State of New Mexico
 Energy, Minerals and Natural Resources

OIL CONSERVATION DIVISION
 1220 South St. Francis Dr.
 Santa Fe, NM 87505

Cato San Andres Unit #055

Chaves County, NM / API 30-005-10560

Proposed Wellbore Diagram

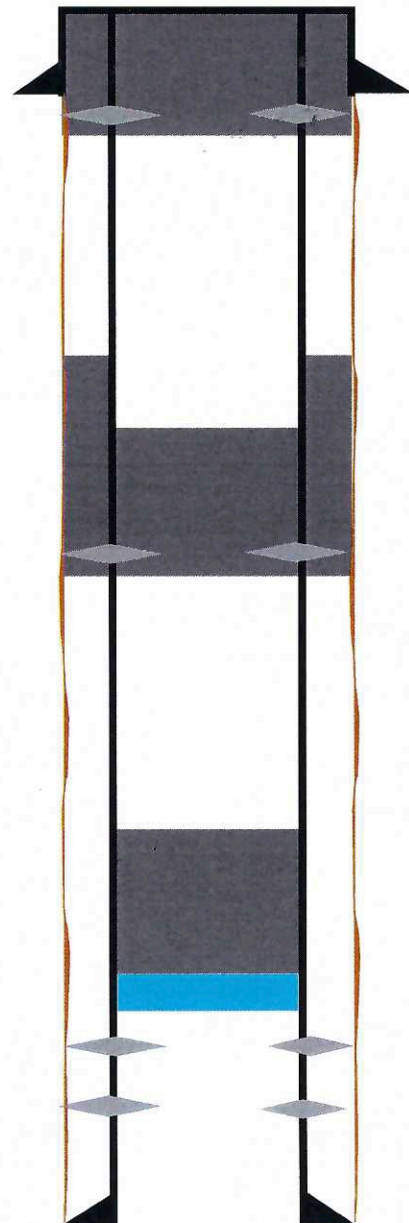
LPC Area Below ground marker send pics before backfilling hole
